RE: BEHS PSC - BG 25-145 - Change Order 16 - Geothermal Water Treatment & Wall Heater Add

Change Order

Change Order Number: 016

PROJECT:	Phase III Athletics - Bid Package No. 1 Bullitt EAST Physical Science Center Bullitt County Public Schools	REQUEST FOR PROPOSAL NO.:	06
OWNER:	Bullitt County Public Schools 1040 Highway 44 East Shepherdsville, KY 40165	DATE:	25-Feb-2026
TO CONTRACTOR:	Calhoun Construction Services, Inc. 7707 National Turnpike Louisville, KY 40218	ARCHITECT:	Studio Kremer Architects 1231 S Shelby Street Louisville, KY 40203
		ARCHITECT'S PROJECT NO.:	2023-50.1 BG# 25-145

1 BULLITT EAST FIRST FLOOR - EQUIPMENT CONNECTIONS
 SCALE: 1/8" = 1'-0"

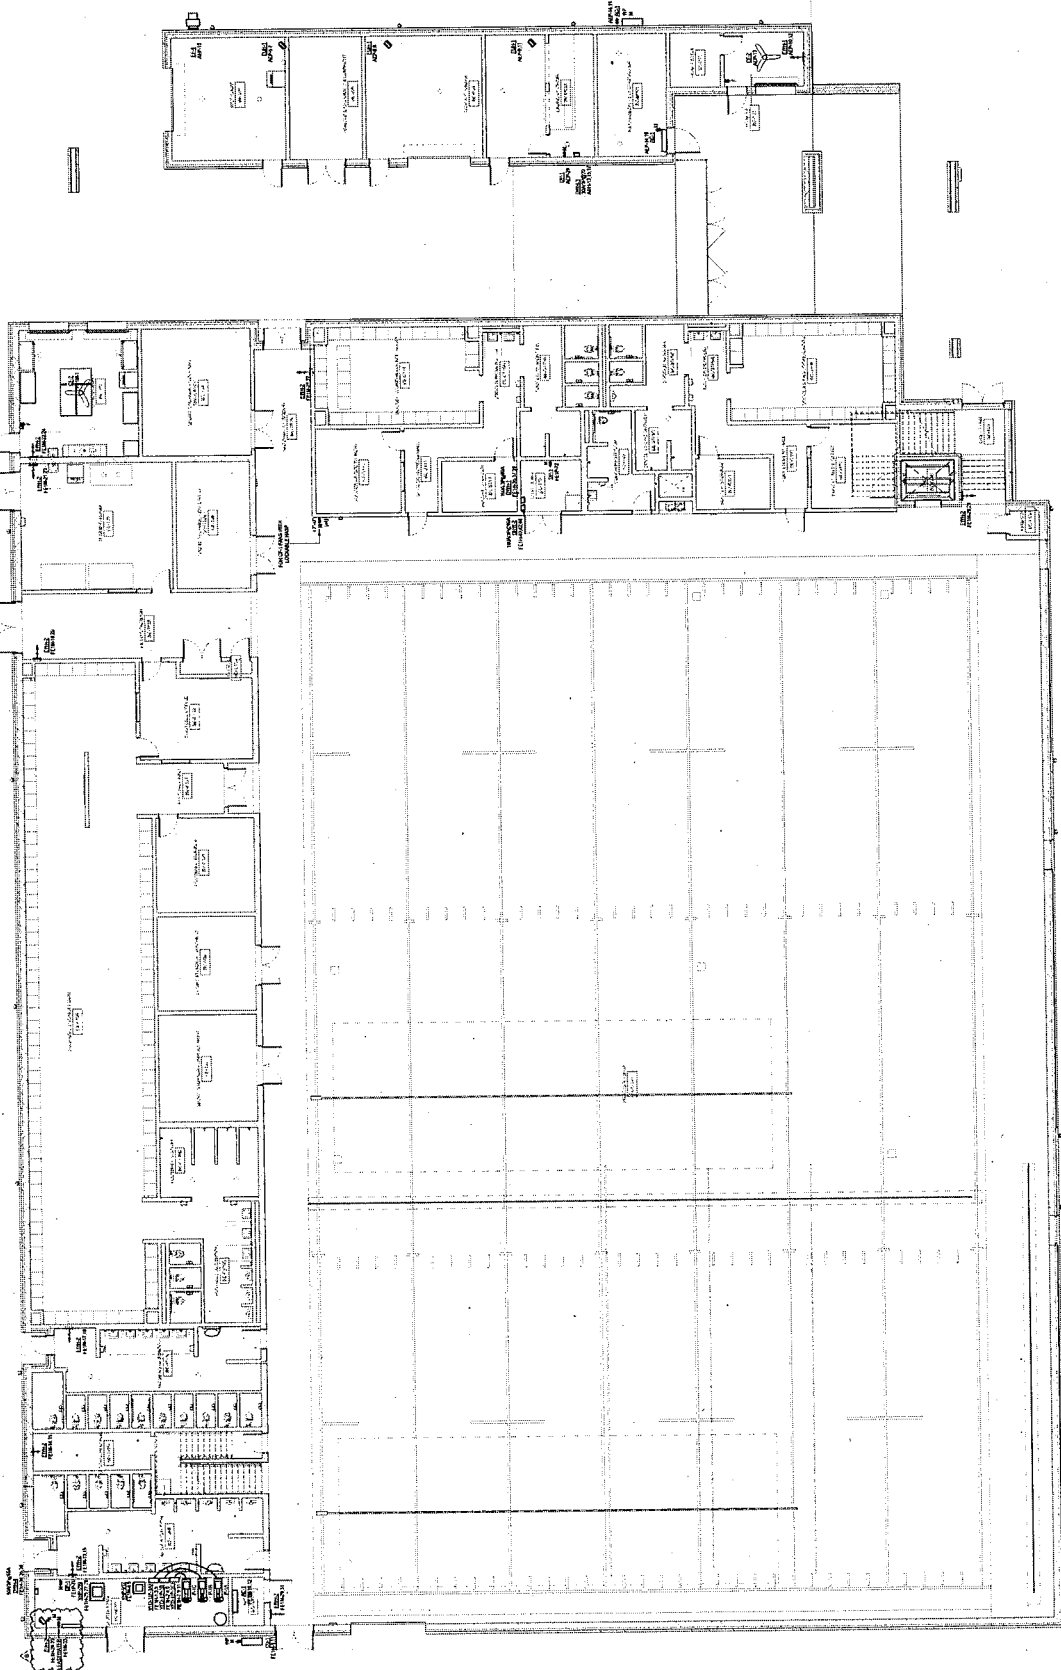
- Item No.1** Refer to revised Drawing M2.01 BEHS:
- ELECTRIC WALL HEATER Added in Room BE-M101
- Item No.2** Refer to revised Drawing M3.01 BEHS:
- EASTWATER CLOSED LOOP WATER TREATMENT SYSTEM Added in Room BE-M101
- Item No.3** Refer to revised Drawing M7.01:
- Mechanical Schedules updated following additional equipment shown in Room BE-M101.
- Item No.4** Refer to revised Drawing E1.25:
- POWER for ELECTRIC WALL HEATER & WATER TREATMENT SYSTEM Added in Room BE-M101
- Item No.5** Refer to revised Drawing EE7.8:
- Electrical Schedules updated following additional equipment shown in Room BE-M101.
